STAFF RECOMMENDATION
3621 Richland Avenue
Lot 9, Richland Hall Development
April 22, 2020

Application: New Construction—Infill and Outbuilding
District: Richland-West End Neighborhood Conservation Zoning Overlay
Council District: 24
Base Zoning: RS7.5
Map and Parcel Number: 10409029800
Applicant: Chad Gore, Mike Ford Builders
Project Lead: Jenny Warren, jenny.warren@nashville.gov

<p>Description of Project: Application is to construct a new single-family infill and an outbuilding.</p> <p>Recommendation Summary: Staff recommends approval of the project with the following conditions:</p> <ol style="list-style-type: none">1. The finished floor height be consistent with the finished floor heights of neighboring historic houses, to be verified by MHZC staff in the field;2. Staff approve the materials prior to purchase and installation, including: windows and doors, garage doors, brick, shingle color, porch materials and outbuilding awning material <p>With these conditions, staff finds that the project meets Sections II.B. of the <i>Richland-West End Neighborhood Conservation Zoning Overlay: Handbook and Design Guidelines</i>.</p>	<p>Attachments</p> <ul style="list-style-type: none">A:

Figure 1. Overall site plan for the 22 infill houses planned for the Richland-West End Neighborhood Conservation Zoning Overlay. The red box indicates the site currently under consideration.

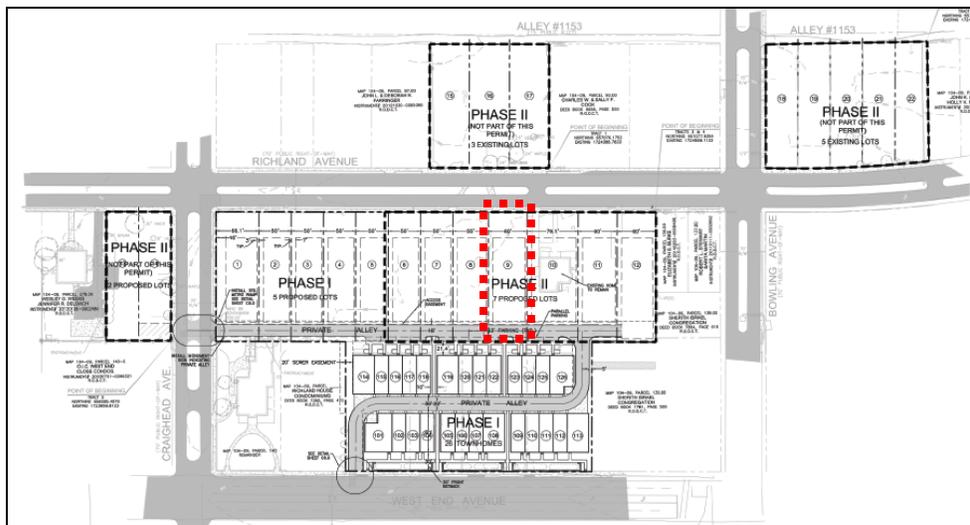
The proposed infill will have a front setback of about fifty-three feet (53’). The infill house to the right was approved by the Commission to have a front setback of forty-six feet (46’) to the front wall of the house. The historic house to the left has a deeper setback at approximately sixty feet (60’) to the front porch. Staff finds that the proposed fifty-three foot (53’) front setback ‘splits the difference’ between these two houses and thus meets the design guidelines and the historic context.

The right-side elevation will be seven feet (7’) from the side property line, which meets the required base zoning setback of five feet (5’) and creates ten feet (10’) of distance to the house next door on lot 8. The Commission approved the house on lot 8 with a three foot (3’) side setback, with the understanding that this house on lot 9 would be sited to create at least ten feet (10’) of separation. On the left side, the house will be five feet (5’) from the left side property line.

The back of the house will be more than sixty feet (60’) from the rear property line.

Staff finds that the infill meets section II.B.1.c. of the design guidelines.

Figure 4. Right side elevation

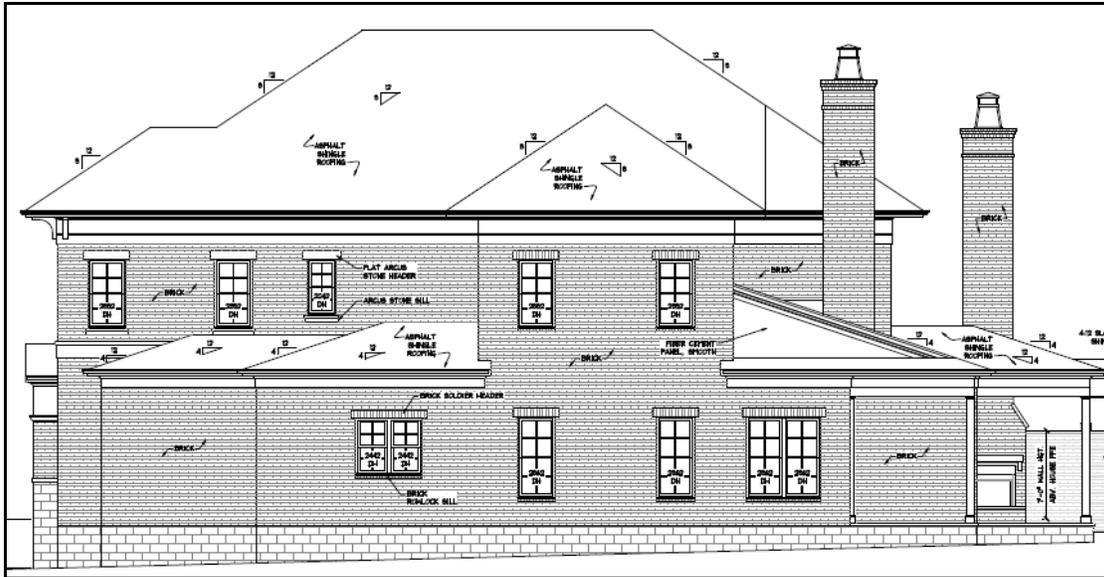
Proportion and Rhythm of Openings: The proposed windows on the infill are generally twice as tall as they are wide, thereby meeting the historic proportion of window openings. There are no large expanses of wall space without a window or door opening. All window groupings have a four to six-inch (4”-6”) mullion in between the individual window openings. Staff finds that the infill’s proportion and rhythm of openings meet Section II.B.1.g. of the design guidelines.

The plans include a brick privacy wall and a chimney at the rear porch. A covered walkway connects the detached garage to the back porch. The Commission has approved such walkways in the past, when there are no side walls, such as in this case. The HVAC unit will be located on the right-side elevation about twenty feet (20’) from the front of the house. Staff finds that the infill meets Section II.B.1.i of the design guidelines.

Figure 5. Outbuilding. Elevation facing the back of the house.

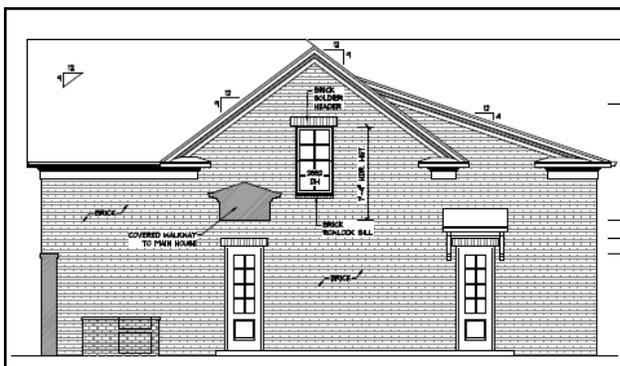
Outbuilding: The outbuilding will not contain a dwelling unit. This site is zoned for single family, and DADUs are not permitted under the current zoning.

The Commission typically requests to see at least twenty feet (20') between the primary structure and the outbuilding. The applicant is proposing just ten feet (10') between the structures. The Commission has approved the distance of ten feet (10') between the primary structures and the outbuildings for other lots on this block. The overall development is creating a new alley at the rear of these lots, using the rear thirty feet (30') of the lots for this purpose, and making the back portion of the lot unavailable for building. The outbuilding cannot be pushed any further to the rear because of this new alley; therefore, staff finds that the distance between the primary house and the outbuilding to be sufficient.

MHZA requires that outbuildings be located a minimum of five feet (5') from the rear property line and five feet (5') from the side property lines. The outbuilding will be more than twenty feet (20') from the rear property line, although it will appear to be much closer because the rear portion of the lot will be dedicated to a new private alley. The outbuilding will be five feet (5') from the left side property line and about fourteen feet (14') from the right side property line.

Staff finds that the proposed outbuilding meets the guidelines for setbacks for an outbuilding.

The proposed outbuilding will be constructed on an twelve thousand, seventy-six (12,076) square foot lot. On lots greater than ten-thousand (10,000) square feet, outbuildings can

have a maximum square footage of up to 1,000 square feet. The proposed outbuilding meets this requirement with a footprint of about eight hundred and sixty (860) square feet.

With the final approval of all materials, staff finds that the proposed outbuilding meets Section II.B.1.h of the design guidelines.

2. Staff approve the materials prior to purchase and installation, including: windows and doors, garage doors, brick, shingle color, porch materials and outbuilding awning material

1 ROOF PLAN
 1/8" = 1'-0"

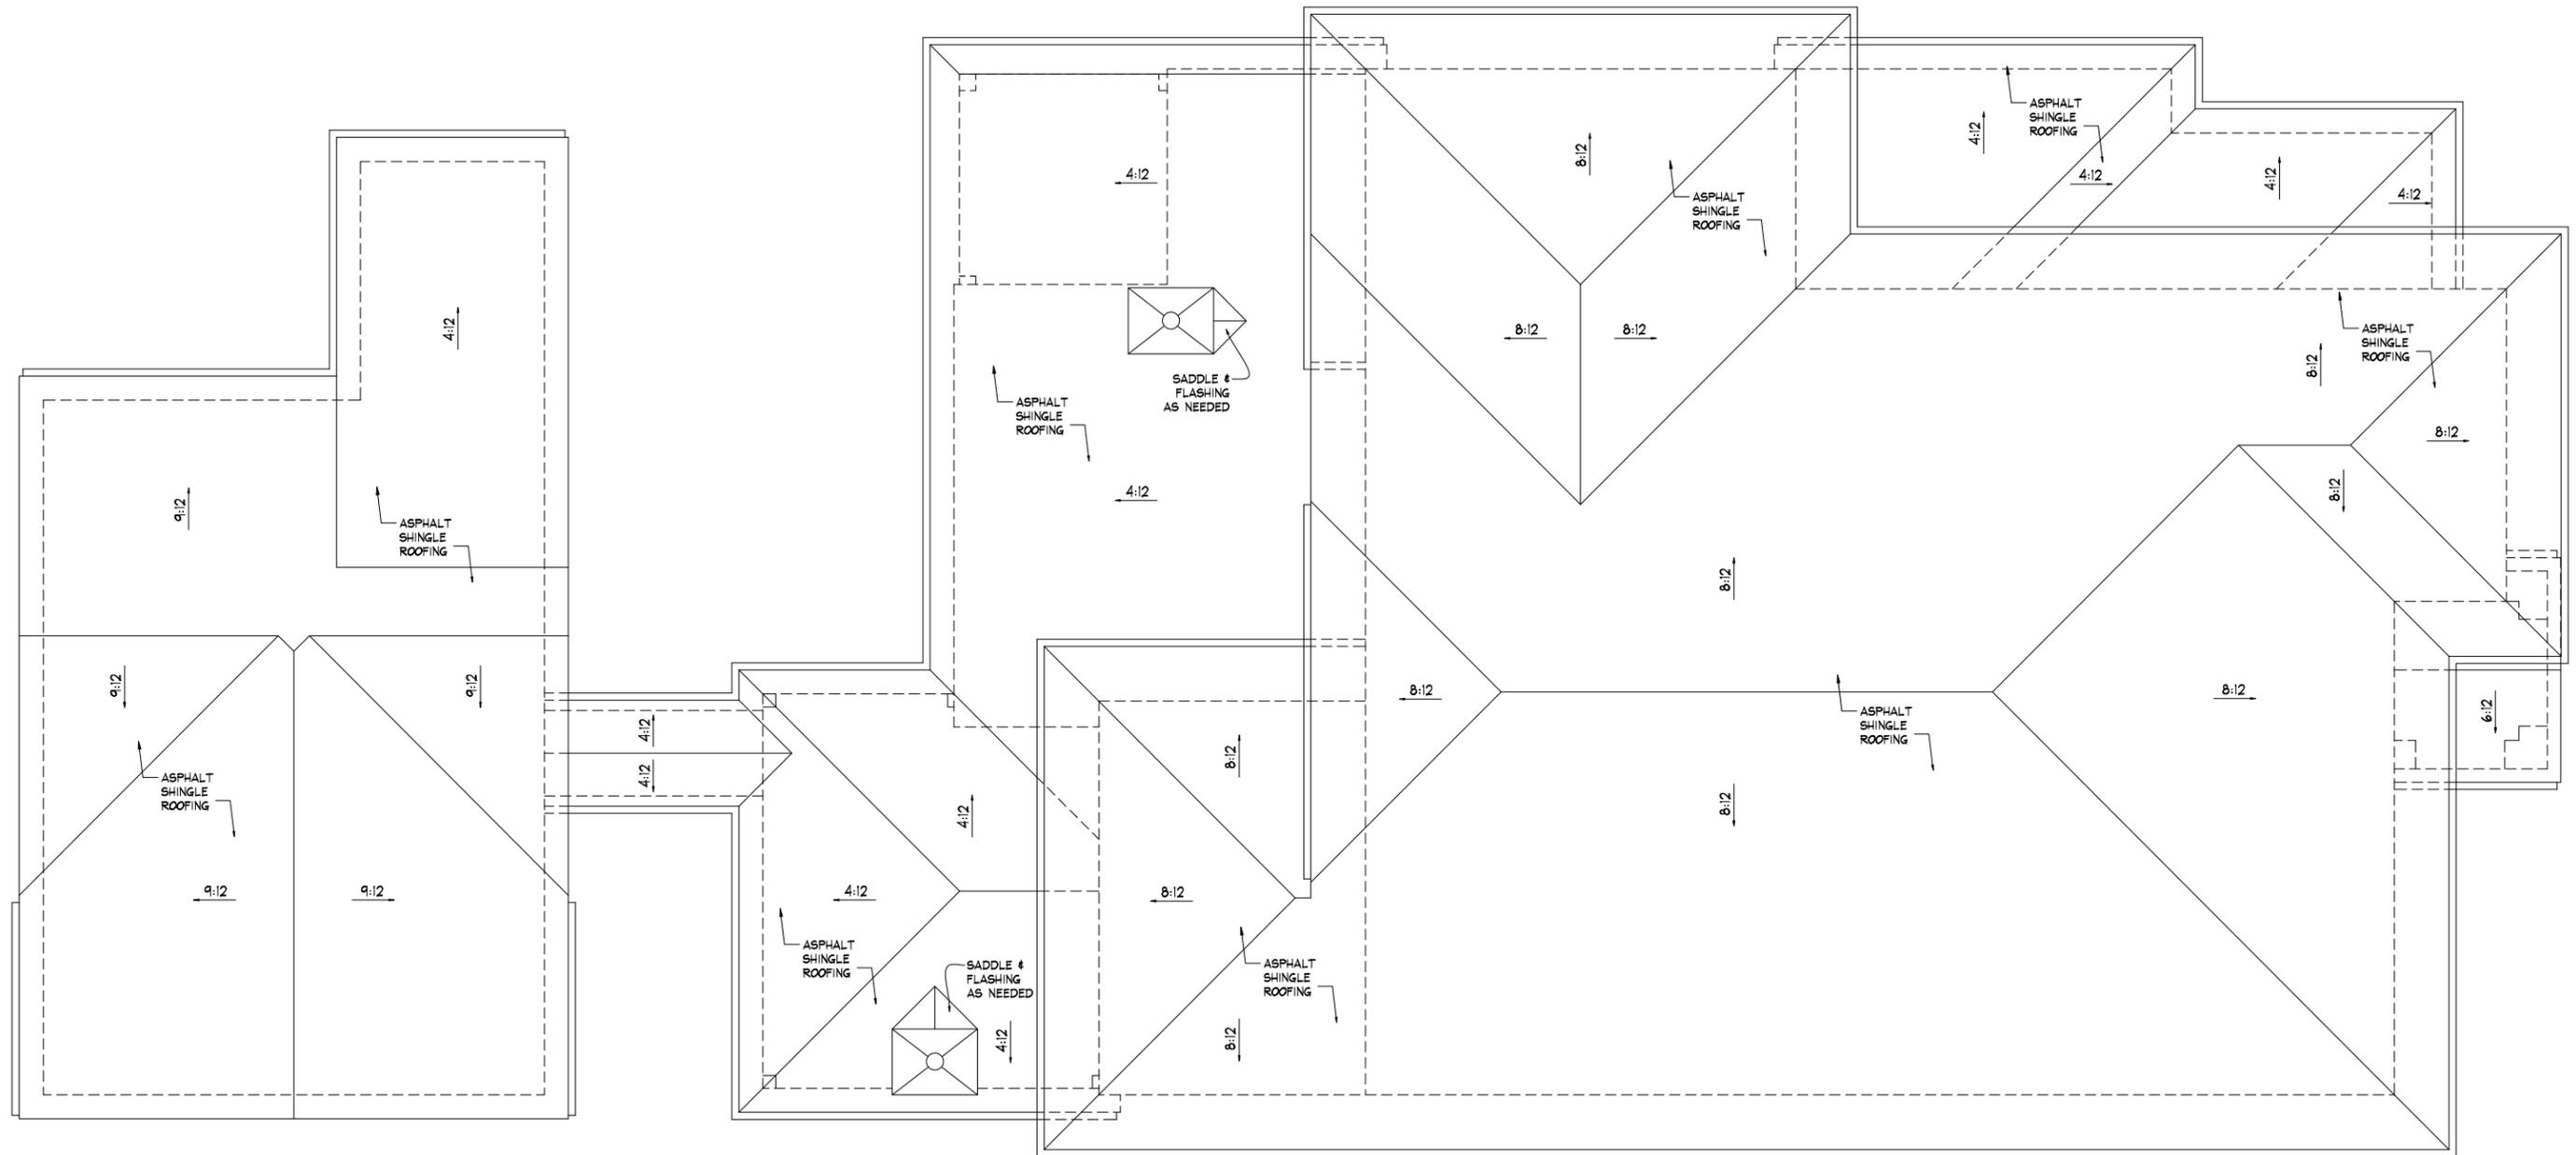
The infill’s primary roof form is hipped. The slope is 8/12. The covered entry has a front-facing gable with a 6/12 slope.

Staff finds that the proposed roof forms are appropriate for a two-story infill house in the overlay; and finds that the roof forms meet Section II.B.1.e. of the design guidelines.

1 FRONT ELEVATION
1/4" = 1'-0"

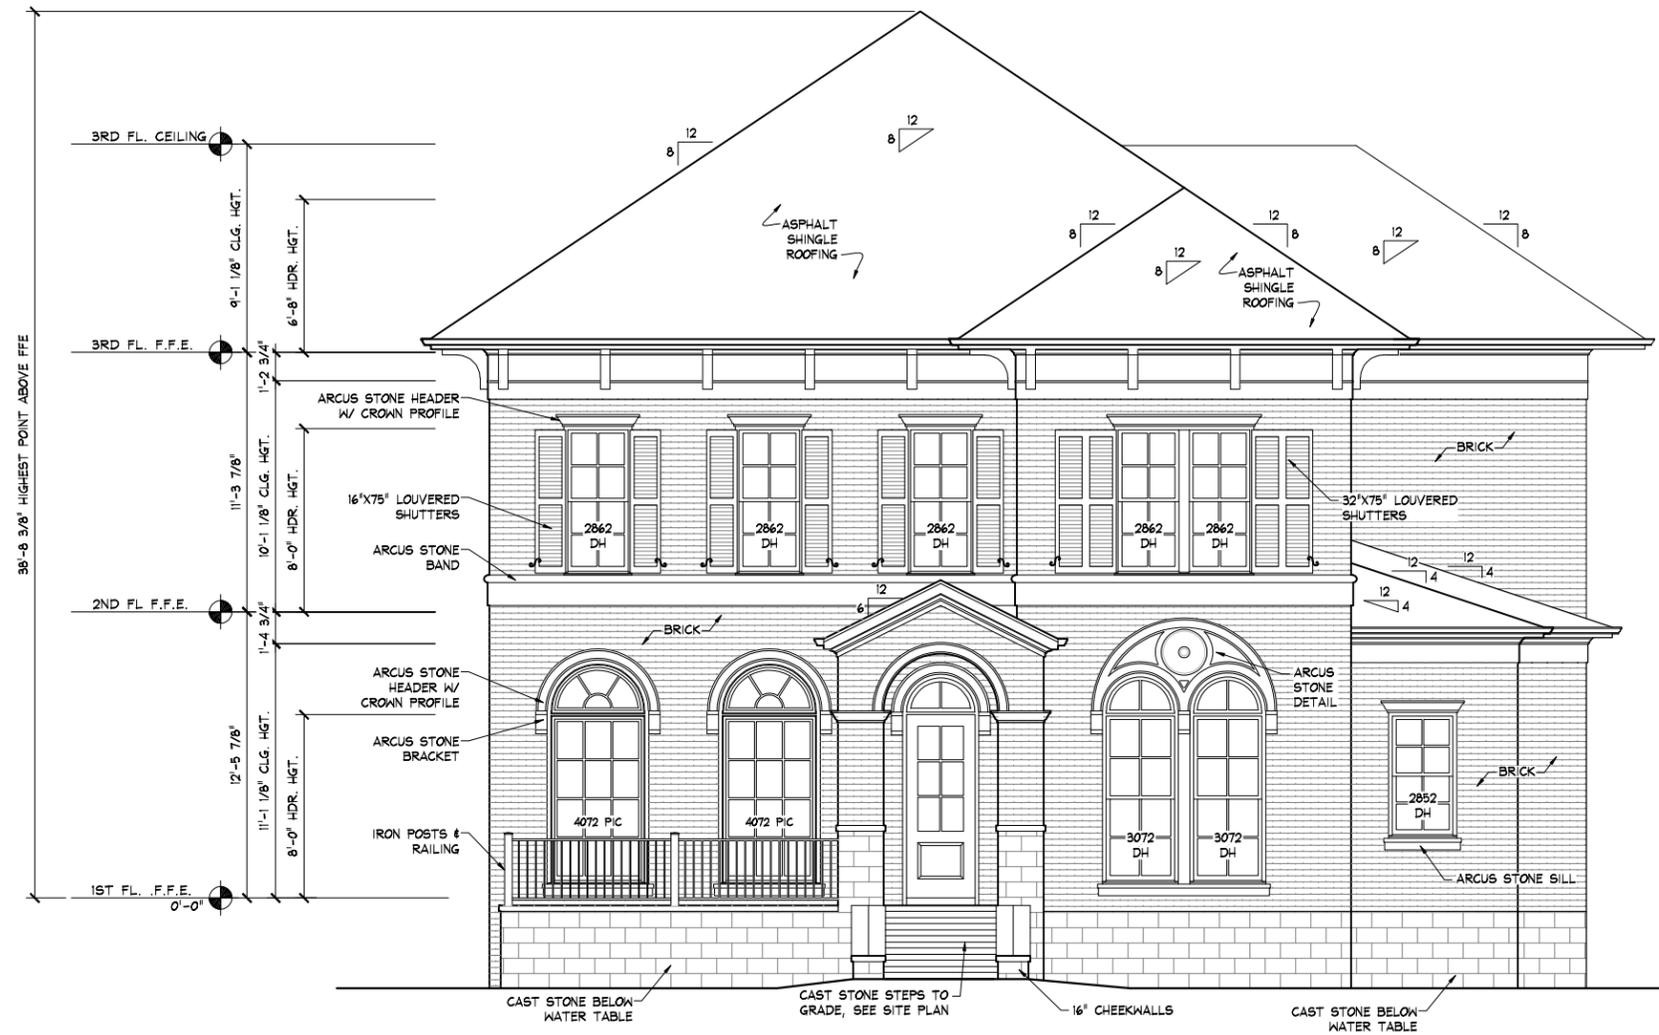
The house is oriented towards Richland Avenue, which is appropriate. There is a central covered entryway at the front door and an uncovered partial width front porch. Most historic houses in the Richland-West End Neighborhood have partial or full-width front porches.

A front walkway will be added from the sidewalk to the front porch. Vehicular access will be via an alley created at the rear of the lot. Staff finds that the infill’s orientation meets Section II.B.1.f. of the design guidelines.

1. The finished floor height be consistent with the finished floor heights of neighboring historic houses, to be verified by MHZC staff in the field;
